Reference: 2265 Laurel Lane - CPD Amendment
DCI2024-00019 (4th ReSubmittal)

**Laurel Lane CPD
Schedule of Deviations
Revised 10-19-2024**

2265 LAUREL LANE
MASTER CONCEPT PLAN

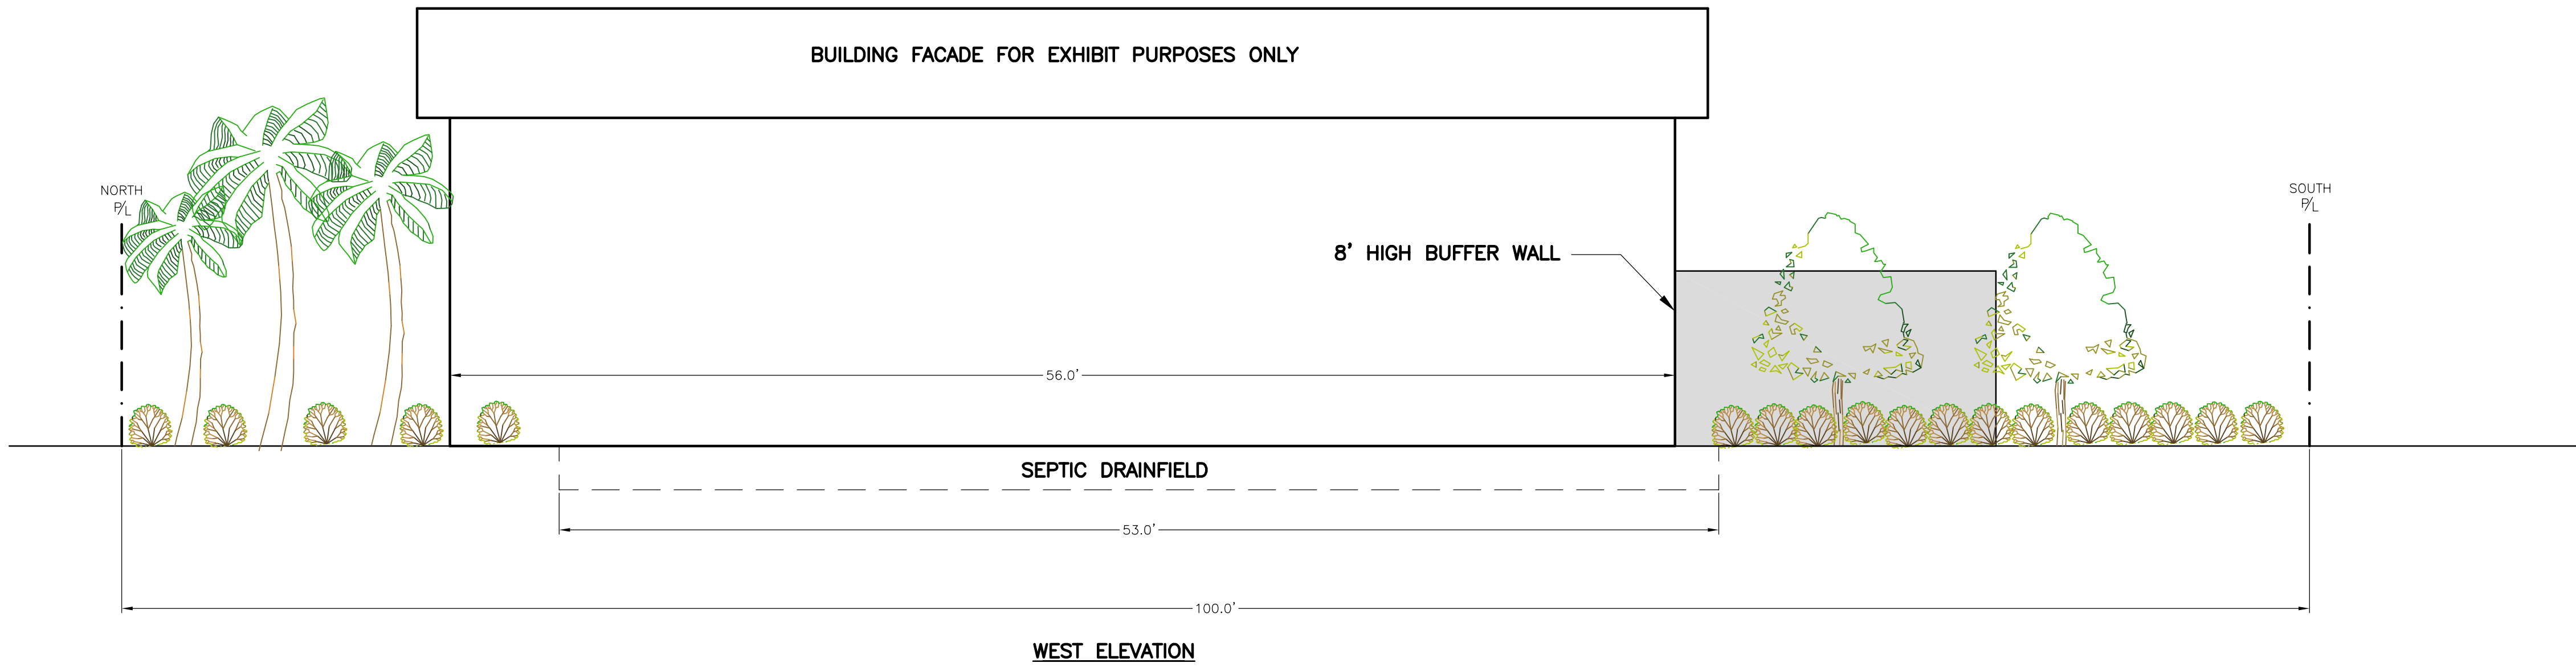
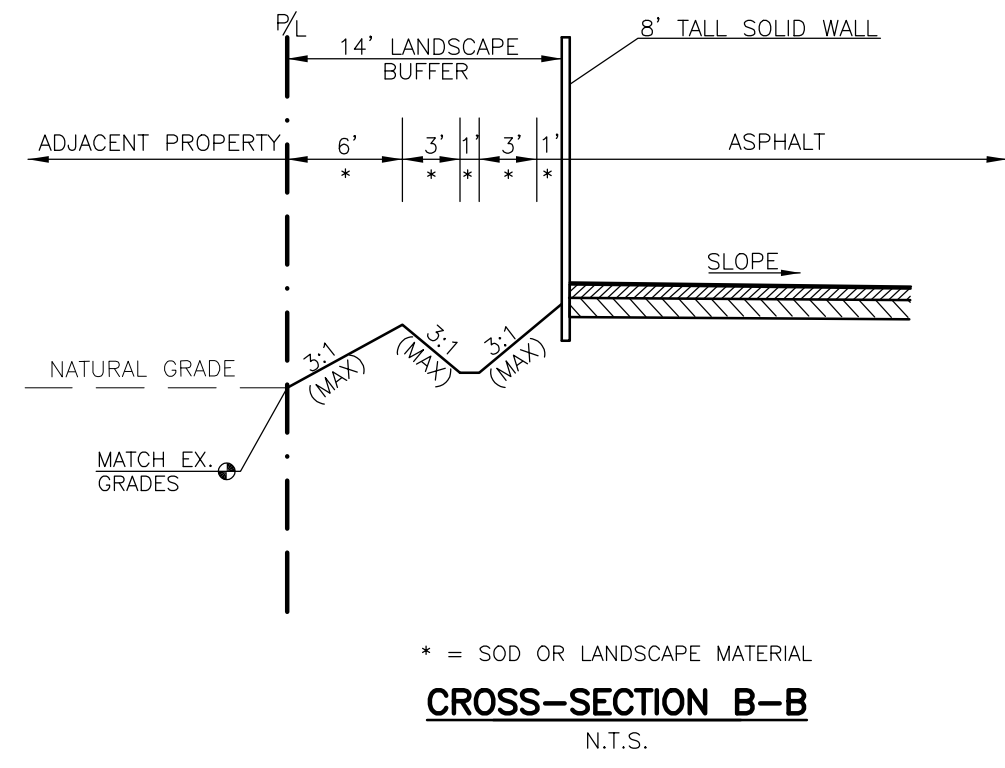
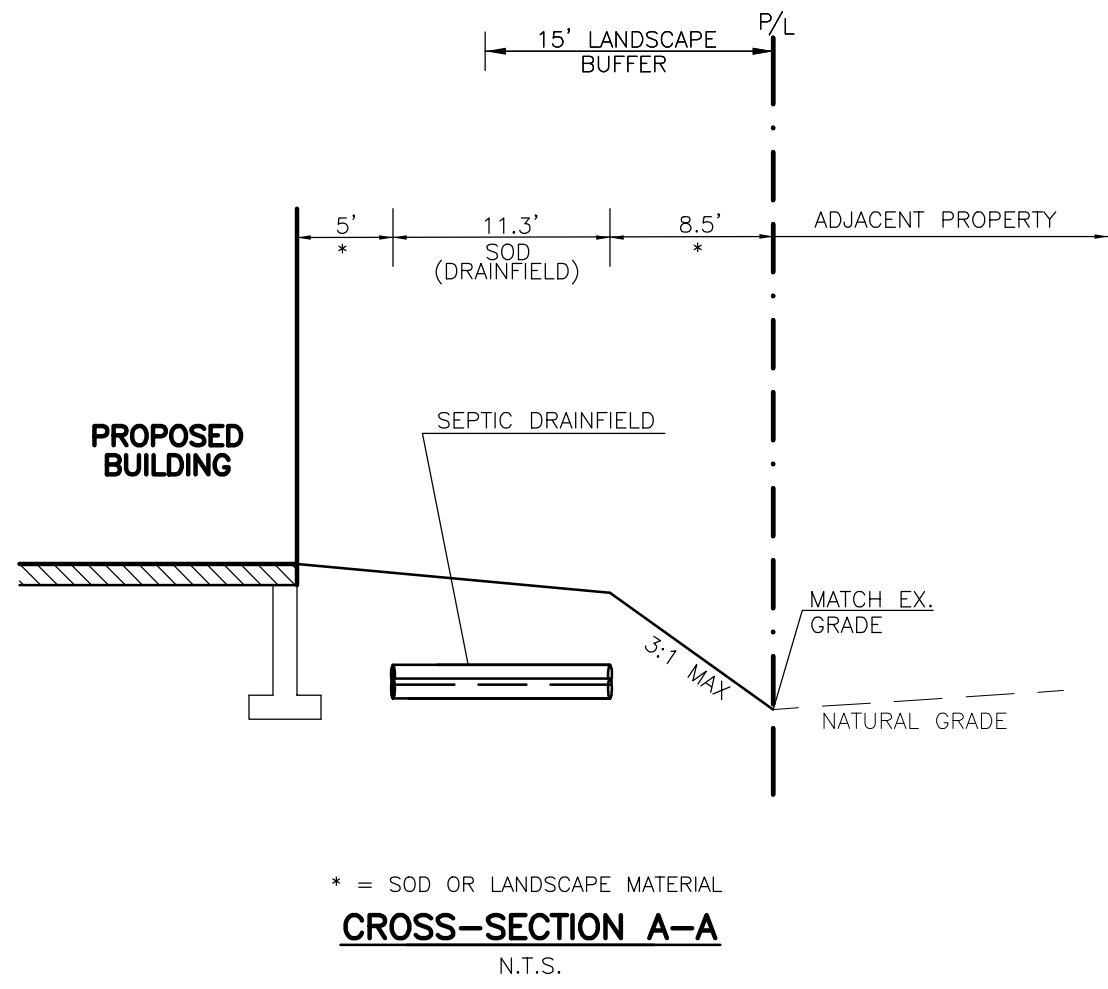
1. Depict the 8-foot wall on the MCP. Staff is not understanding how the buffer requirements will be met and also be compatible with the septic drainage areas. Please depict the location of the 8-foot wall on the MCP, all cross sections, and provide a buffer typical depicting how the landscaping will be installed to not impact the septic drainage area.

2. The MCP notes an 8-foot wall and cross section A-A does not depict the location of the 8-foot wall. Revise cross section A-A to depict the wall.

3. It is unclear as to how the required plantings for the south and west buffers will be installed abutting septic drainage areas. The cross sections do not depict the trees and shrubs required per LDC Section 33-1543. In addition, explain how the root systems will not impact the drainage fields.

Response: A 15-foot wide Type C buffer is proposed along the west property line; however, the applicant is proposing that the building act as the buffer wall for a distance of 56 linear feet. No doors or windows will be located on the western façade of the proposed structure and the buffer wall will not extend into the north right-of-way buffer along Laurel Lane. The 8-foot high buffer wall will extend from the southwest corner of the proposed building to connect with the south buffer wall, which is set 14 feet from the south property line per the requested deviation. There's 24.8 feet between the west property line and the proposed building and buffer wall. The septic drainfield is located between the building and west property line and will overlap the 15' wide buffer by 7.50 feet, leaving an 8.5-foot wide planting shelf. A Type C buffer requires five (5) trees and eighteen (18) shrubs per 100 linear feet. In this case, the property width is 100 linear feet, so a minimum of 5 trees and 18 shrubs can be easily planted in

the space available without impacting the septic drainage area. Trees and shrubs with shallow root systems such as pine, crape myrtle, Japanese maple, magnolia, boxwood, holly, etc. are examples that will do well at this location without impacting the septic/drainfield. Please see the revised MCP, cross-sections, and west elevation exhibit for additional information.

Response: Please note that the wall of the proposed building will act as the buffer wall for 56 linear feet as noted on the MCP. Cross-section A-A depicts the location of the building wall, septic drain field and buffer. Please see the revised MCP and cross-sections for the information requested.

Response: There's 24.8 feet between the west property line and the proposed building and buffer wall. The septic drainfield is located between the building and west property line and will overlap the 15' wide buffer by 7.50 feet, leaving an 8.5-foot wide planting shelf. A Type C buffer requires five (5) trees and eighteen (18) shrubs per 100 linear feet. In this case, the property width is 100 linear feet, so a minimum of 5 trees and 18 shrubs can be easily planted in the space available without impacting the septic drainage area. Trees and shrubs with shallow root systems such as pine, crape myrtle, Japanese maple, magnolia, boxwood, holly, etc. are examples that will do well at this location without impacting the septic/drainfield. The south buffer wall is located 14 feet from the south property line per the deviation request. In addition, there's a small drainage swale overlapping a portion of the buffer. Please see the revised MCP, cross-sections, and west elevation exhibit for additional information.
